**PROOF OF EVIDENCE
FOR PUBLIC INQUIRY COMMENCING ON 15th of September 2020**

Former Hampstead Police Station,
26 Rosslyn Hill,
London NW3 1PD

PROOF OF EVIDENCE OF NICK BAXTER

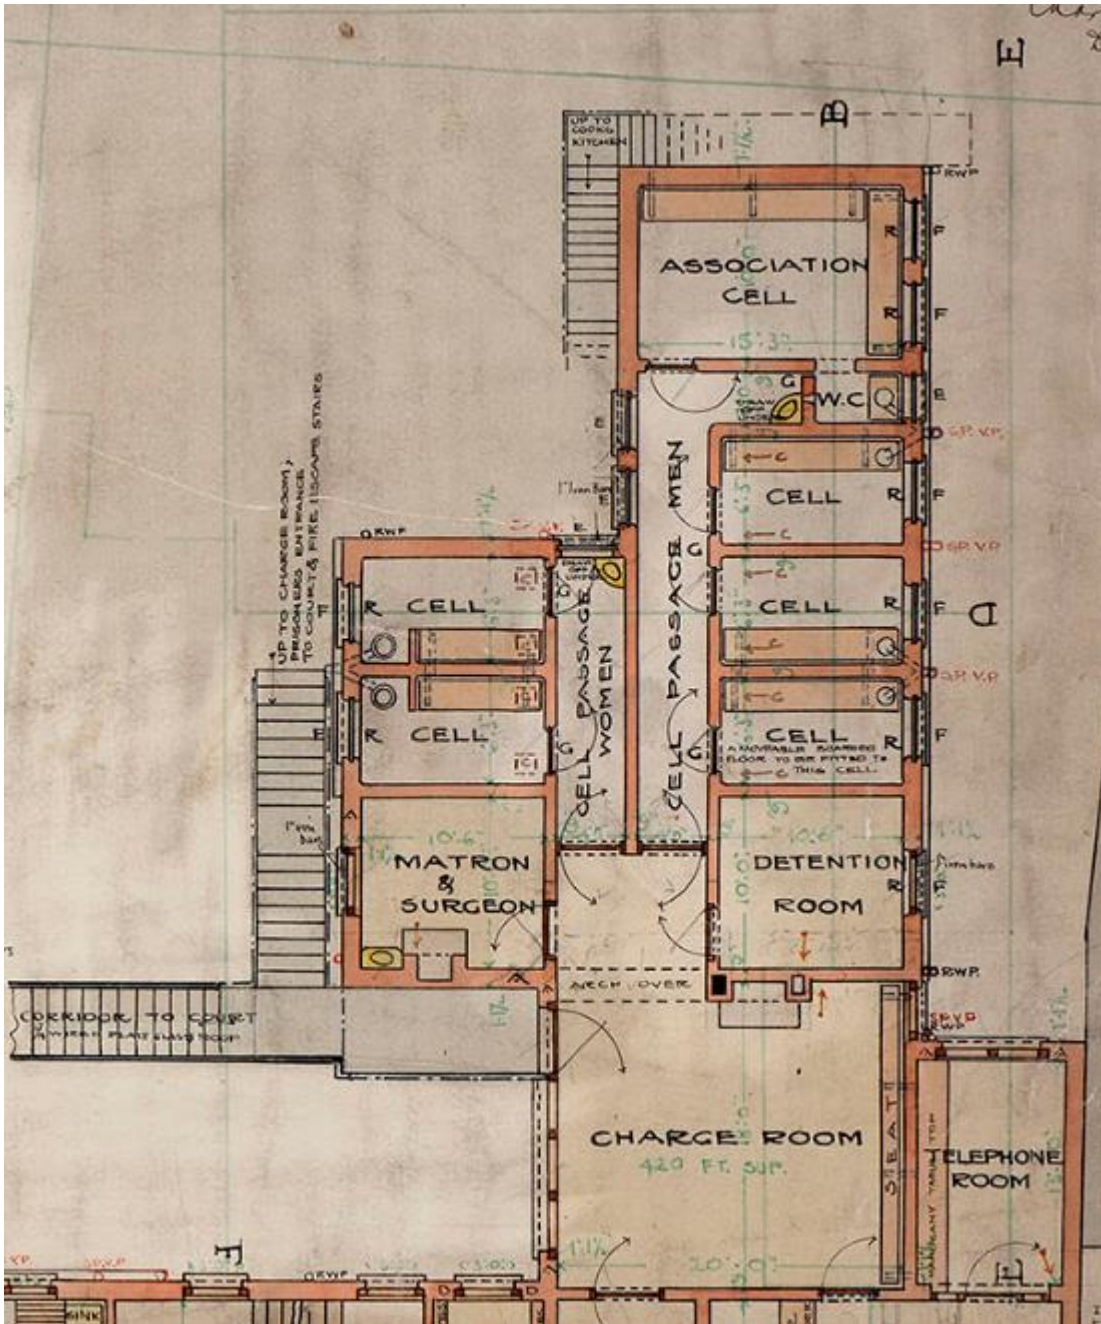
- 4.4 A glance at Dixon Butler’s 1912 elevation, above, shows that the bridge, and the various other external staircases, were original features of his design. Unfortunately, the appellant seems to have mistakenly identified them as later additions and asserted that their removal is therefore *per se* beneficial.

- 4.5 The proposed rear elevation (P1732 202D), above, shows all of the historic communication removed in the guise of a “heritage benefit” (this drawing also fails to show any of the new user’s services or air-handling equipment, which will be discussed later).

- 4.6 Although the bridge’s fabric has been renewed, it is an original feature and provided a direct (if unorthodox) route from the cells to the courtroom without having to go outside or, indeed, through the married officers’ accommodation (which was not possible in any case). Other utilitarian parts of the building, such as the steps down to the former parade room, now cells, and the other external staircases are also seen to be features of the original design.

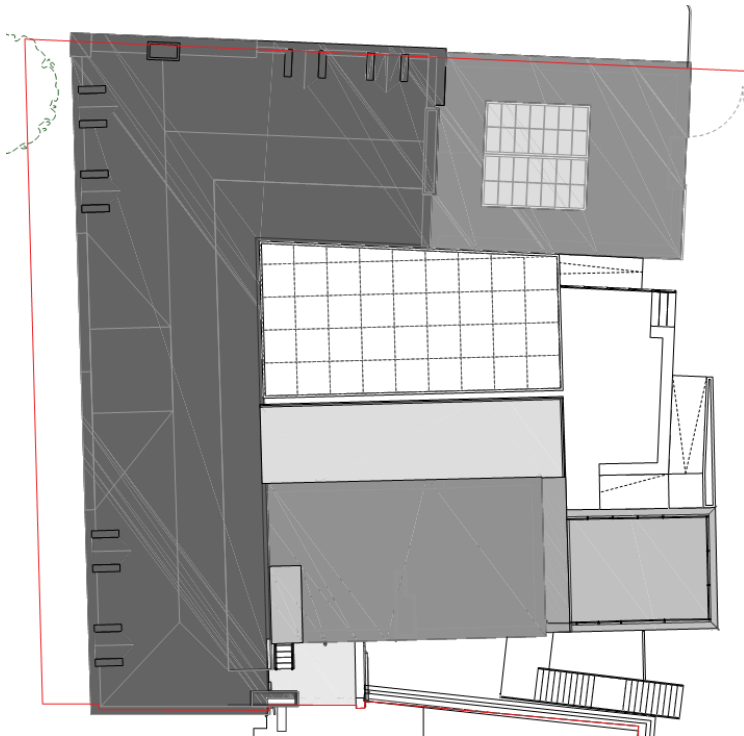
8.4 Unfortunately, each of these three statements appears to be inaccurate. The submitted ventilation diagrams indicate pipework and ducts with yellow and green lines that become harder to see the more one zooms in on them. They are merely schematic, and rather than indicating pipe runs, they show the pipes travelling around the site at right angles and a fixed distance apart. They give no sense of what these services will actually be like, how they will interact with fabric or the effect they will have on the character of the interiors. Coolant pipework for air conditioners can have a relatively small bore (although that is not made clear here and may not be true of this application), but the ventilation component will require the movement of air both in and out of the various rooms, and so will be considerably more substantial.

8.5 No ducts or rooftop heat exchange units appear to be shown on the GA elevations or plans, the drawings that are principally relied upon by decision makers to assess visual impact. Below is the proposed roof plan (1732 250B). Any reasonable person would conclude that no external rooftop plant was proposed:

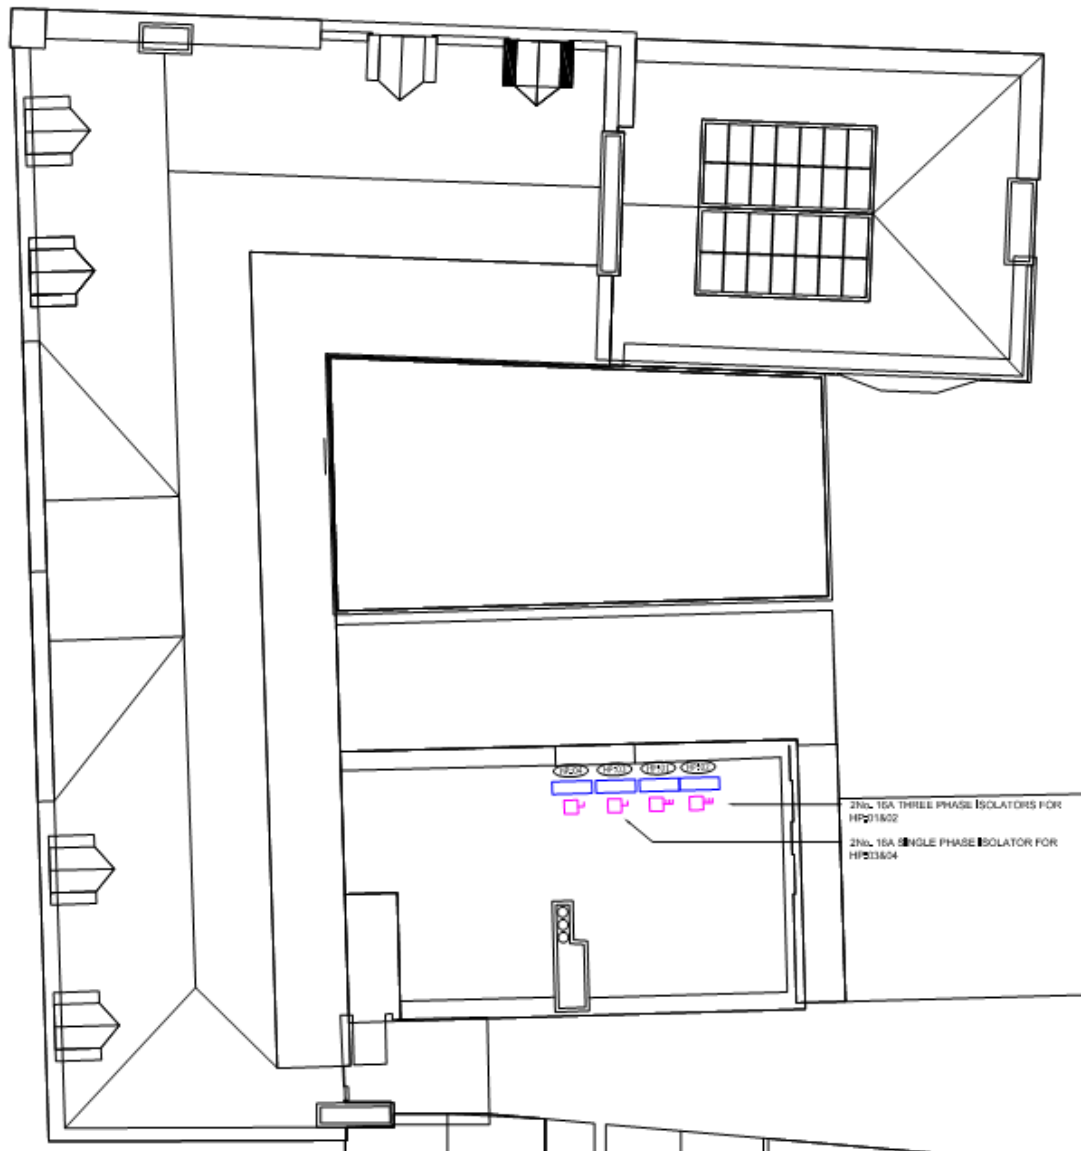
- 8.11 Four rectangles appear on one (not all) of the M&E roof plans (RF PL ME 8301 B, above). They are labelled as HP:01 to HP:04. A determined specialist might extrapolate that these represent the Mitsubishi external heat pumps mentioned on the M&E schedule (XX SC M 4001). However, no indication is given of what these devices actually look like or how big they are. In addition to being omitted from all of the GA elevations and the roof plan shown at 8.5, they are surprisingly omitted from the two M&E elevations (e.g. XX EL M 4301 and XX EL M 4300).
- 8.12 It might be argued that conventionally, air conditioners should not be shown in M&E elevations that don't depict the air conditioning system. But, cumulatively this means that *no elevation* shows the proposed existence of these four machines. And, out of more than three dozen M&E drawings, two plans depict the roof, and one of

those shows it with no air conditioners (because it's not an air conditioning plan).

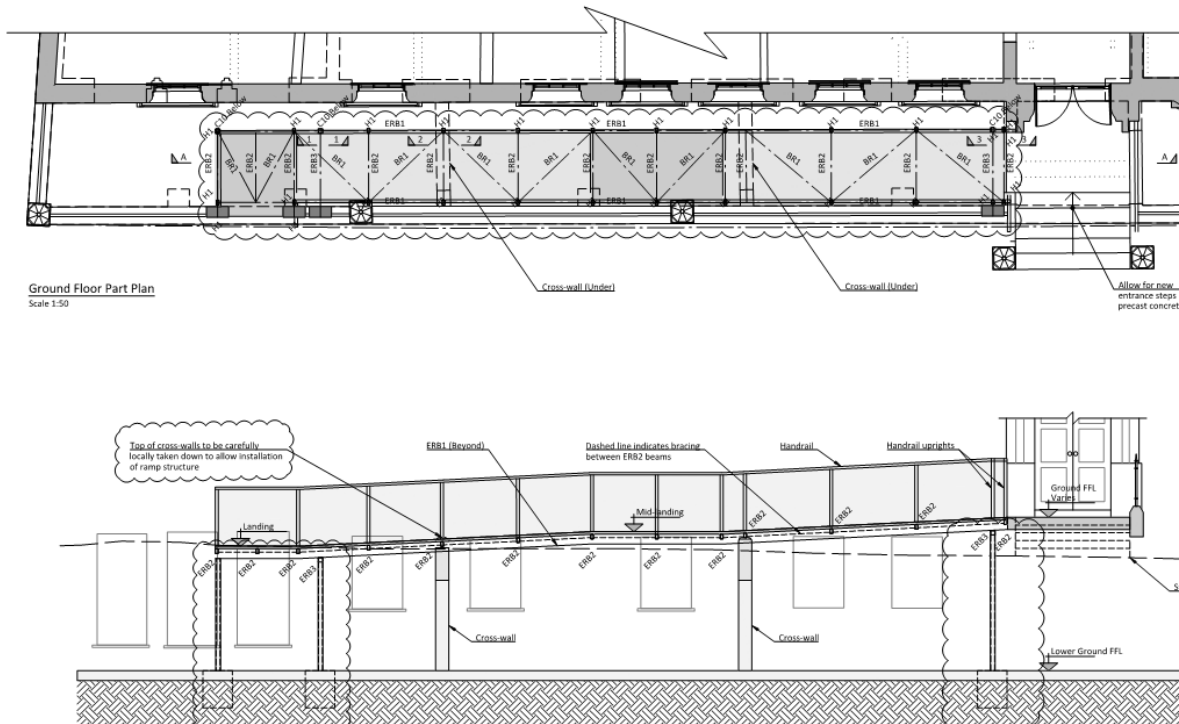
- 8.13 It has been my experience that air conditioners, or external heat pumps, have to stand on substantial frames to eliminate vibration and have to be enclosed within bulky acoustic structures, much larger than themselves, to control noise while allowing air flow. If this is the case here, their purely schematic representation in plan, and their omission from all of the elevations in the M&E drawings, in no way communicates this, and their omission from the GA drawings is unacceptable.

- 8.14 In terms of impact, the drawing (RF PL ME 8301 B, above) appears to show them near the parapet on top of the east wing next the chimney.
- 8.15 If proposed, the addition of this machinery and its bulky enclosures to the skyline will be harmful to the special interest of the listed building.
